PLANNING COMMISSION MEETING

LOCATION: TOWNSHIP ANNEX, 7527 HIGHLAND ROAD, WHITE LAKE, MI 48383
THURSDAY, JANUARY 15, 2026 – 6:30 PM

RE: Edendale Crossing- Preliminary Site Plan Review – 4th Review

Our office has performed a Preliminary Site Plan review for the above-mentioned revised plan dated December 18, 2025. The plans were reviewed for feasibility based on general conformance with the Township Engineering Design Standards.

C:\2025\10 PH Homes - Bogie & Cedar Island\CAD\Entendale Crossing.dwg, 8 Bogie Entrance, 12/18/2025 1:28:03 PM

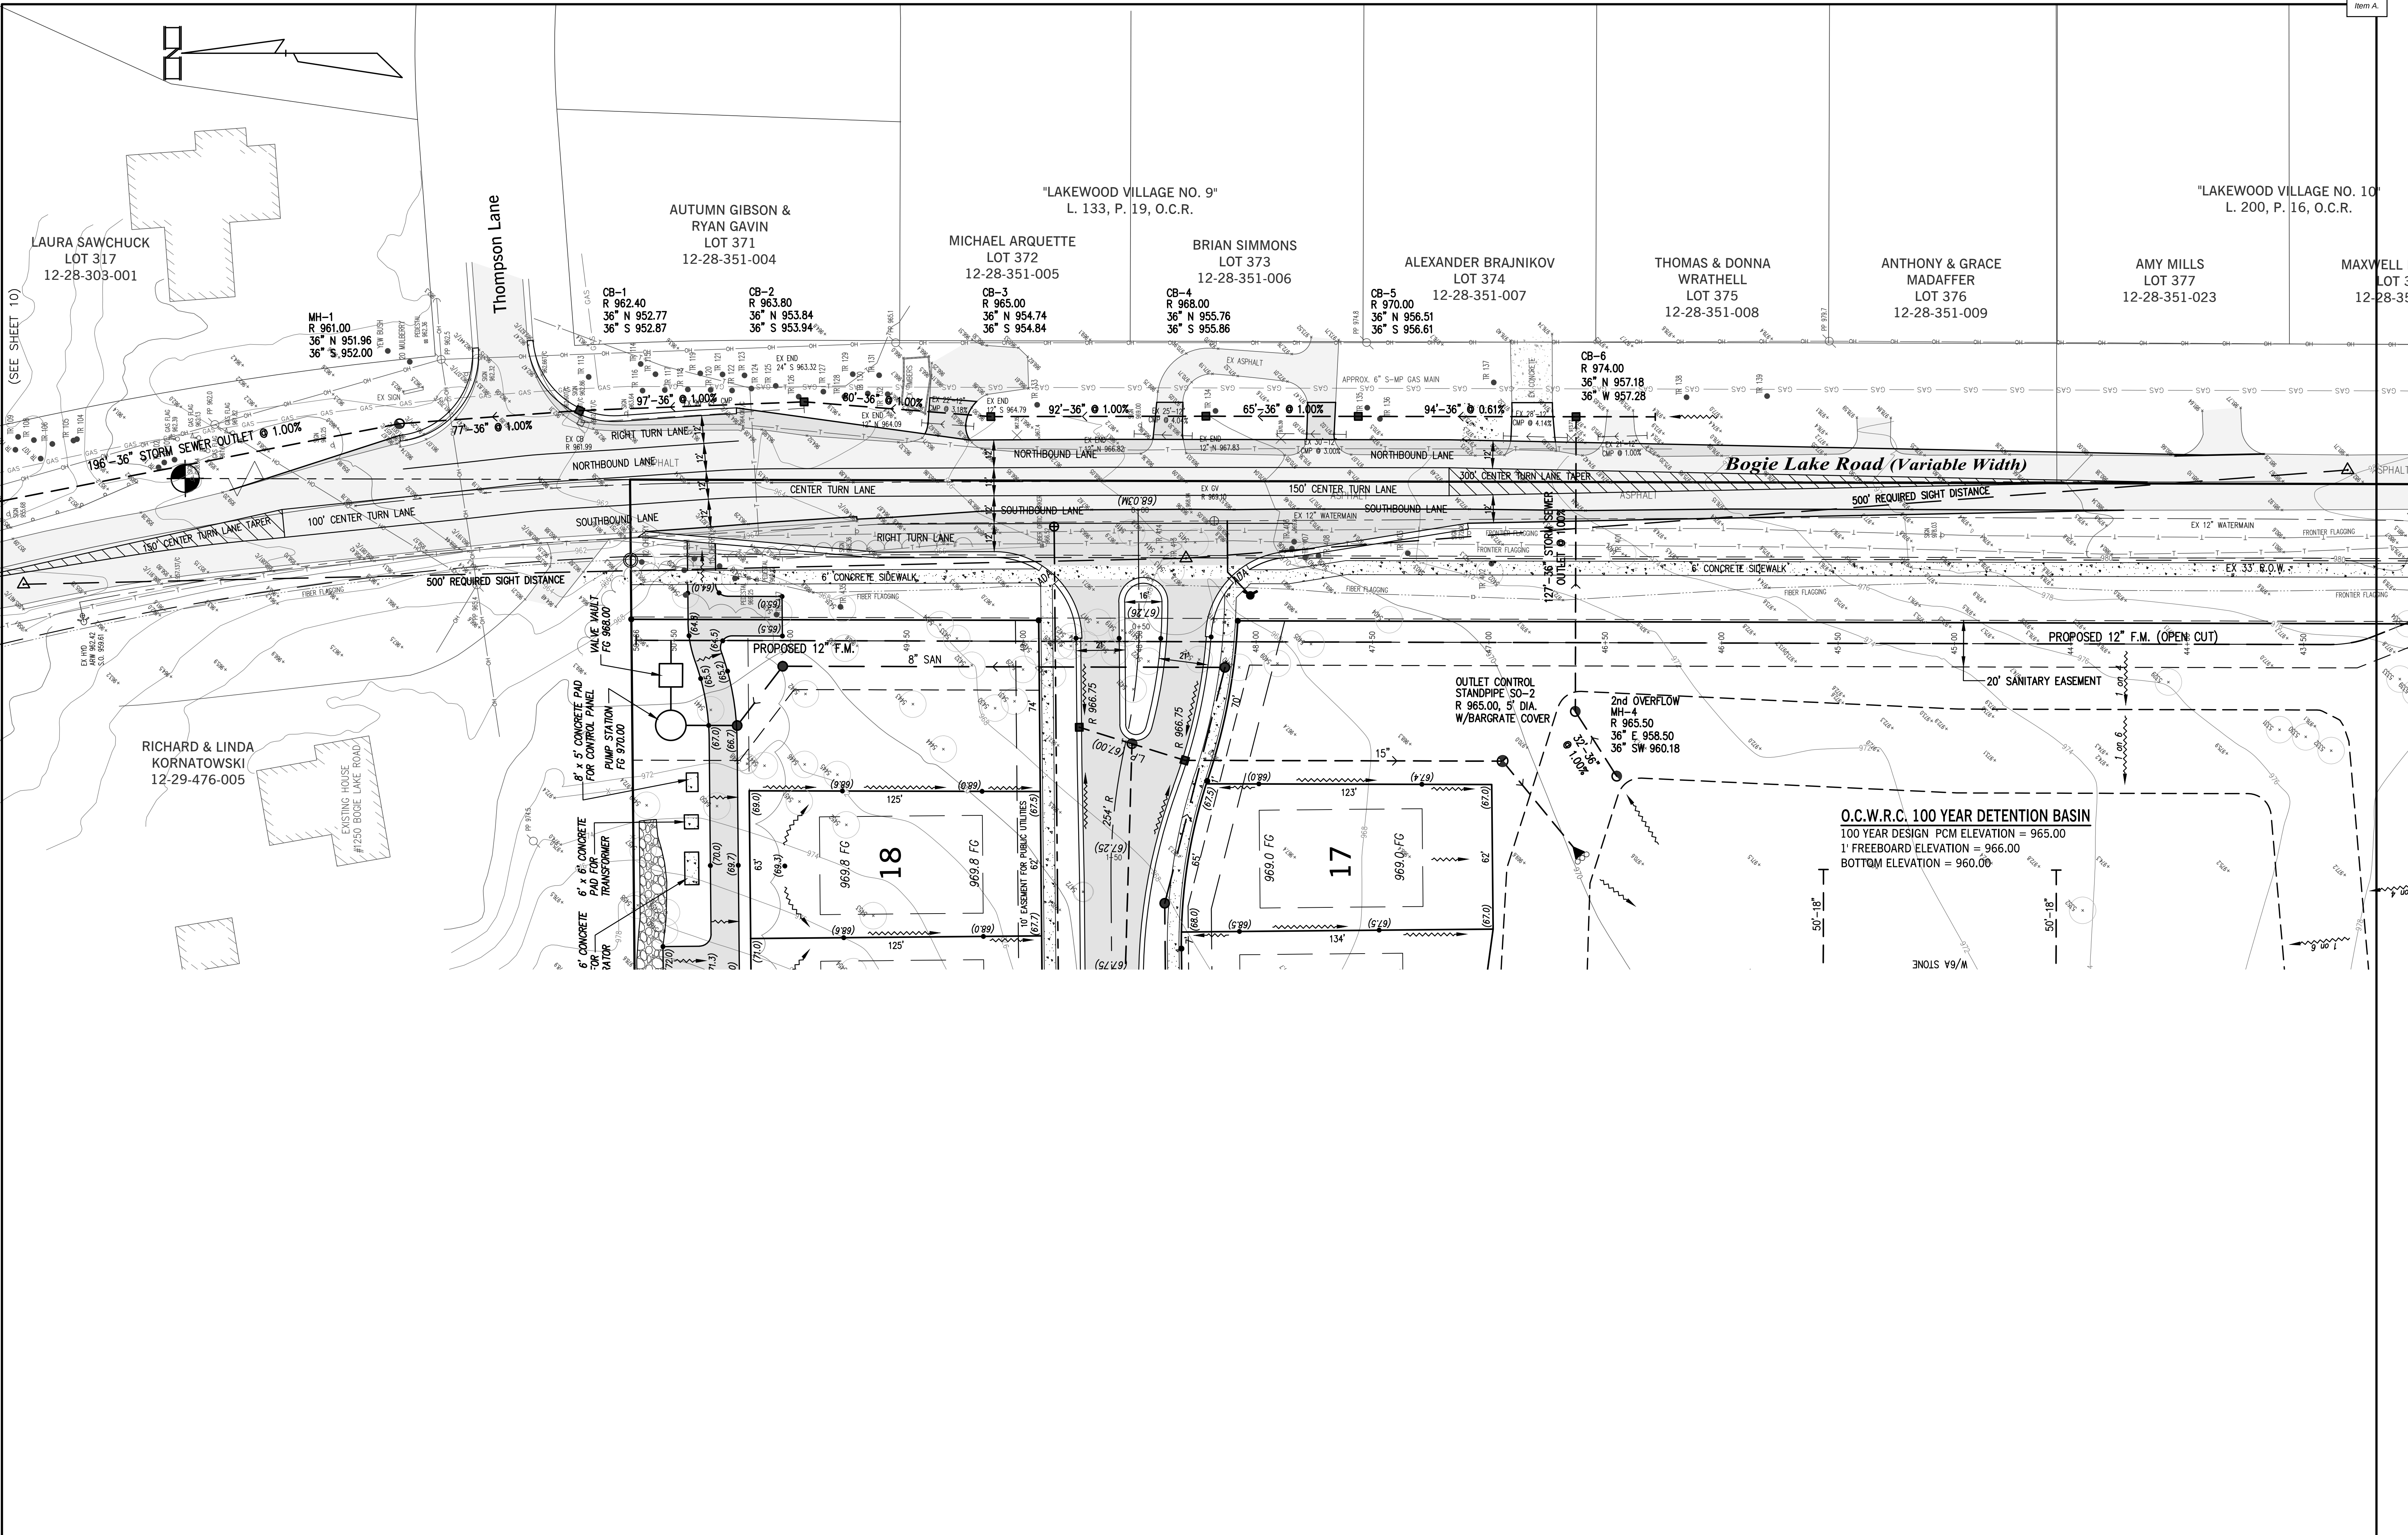
1. *Sheet 8- It appears the discharge from the detention pond will flow across Parcel #12-28-303-001 which may require a storm drainage easement unless the storm sewer can be extended to a point there is no conflict. Comment addressed. A ditch that will route where the drainage to Thompson Lake goes is now proposed within the existing road ROW. **Comments remains as a notation.***

2. *Sheet 8- The proposed storm sewer layout along Bogie Lake Road will need to be clarified at the time of Final Site Plan/Final Engineering Plan to work with existing stormwater features, site drainage, and utility poles etc. **Comment remains as a notation.***

SCALE	1" = 30'
SHEET	16 OF 19
KE	2025.016

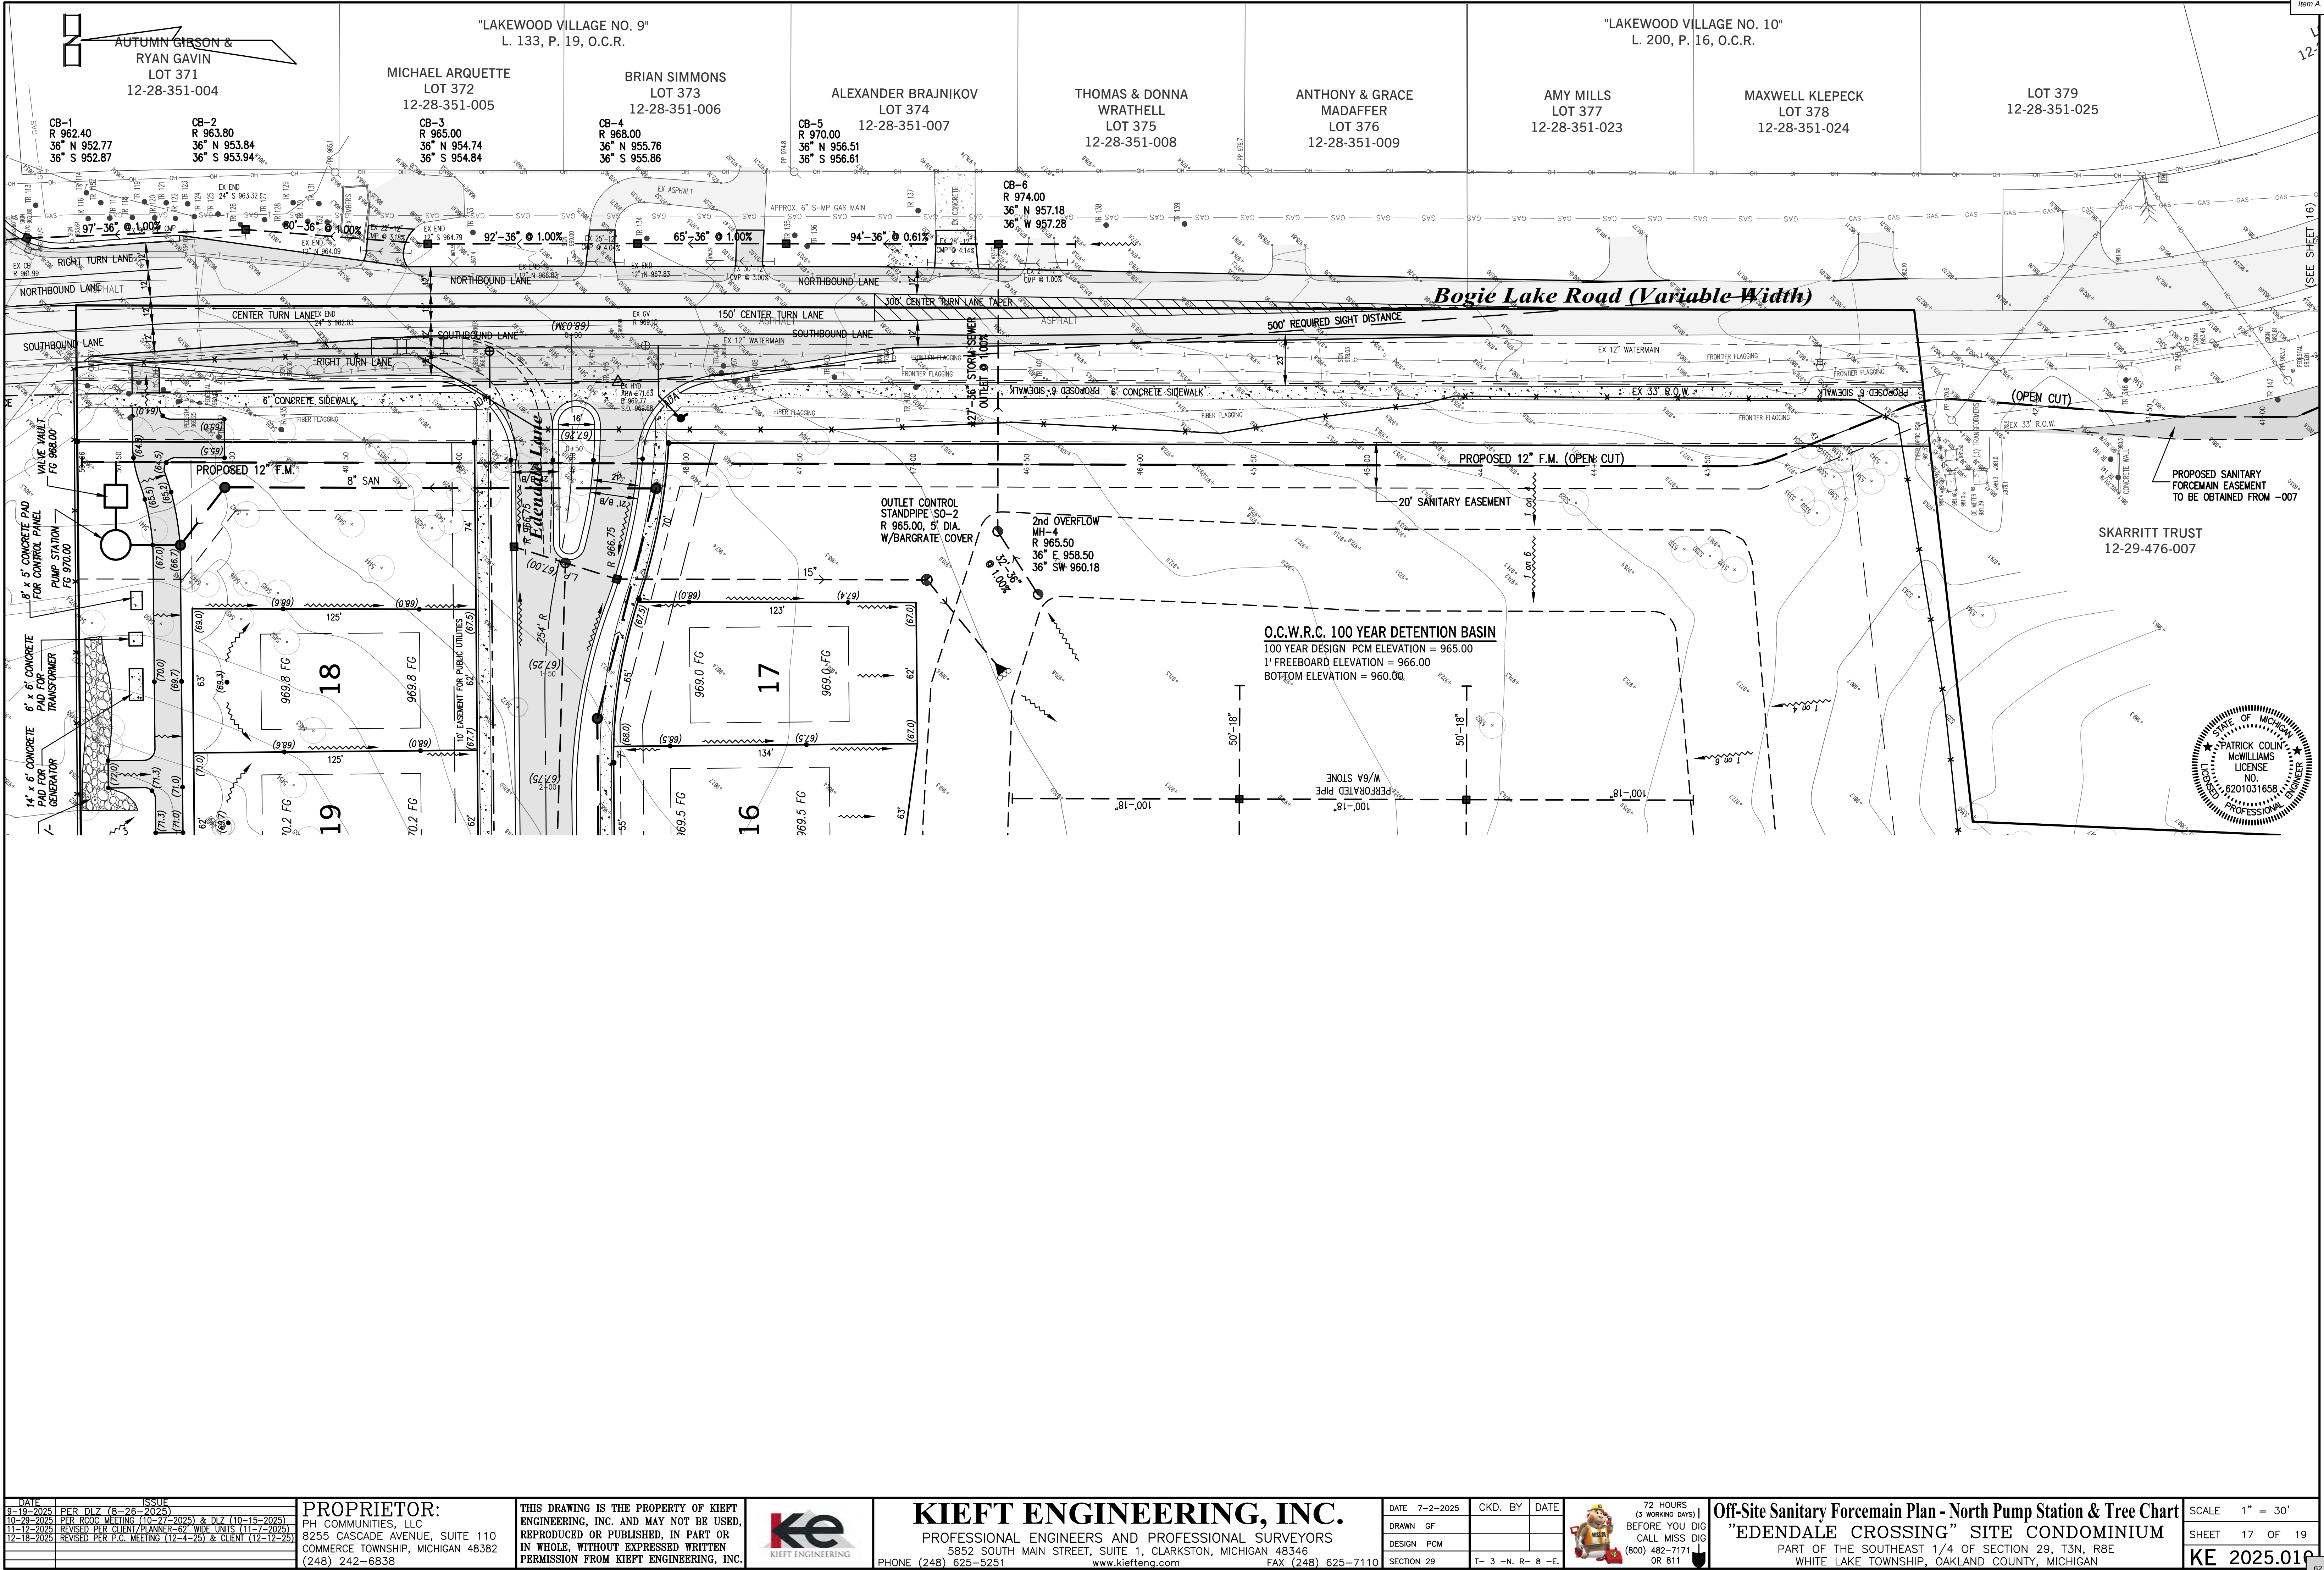
Dimensions for the boulevard access points are provided on Sheet 16. Per the design requirements outlined in table 6.4.C.X, the entrance drive width is sufficient however the exit drive is not wide enough and requires a waiver from the Planning Commission.

Internal sidewalks are shown along all streets as well as cross development pedestrian pathways. These sidewalks are required to be five feet wide as shown on Sheet 16.
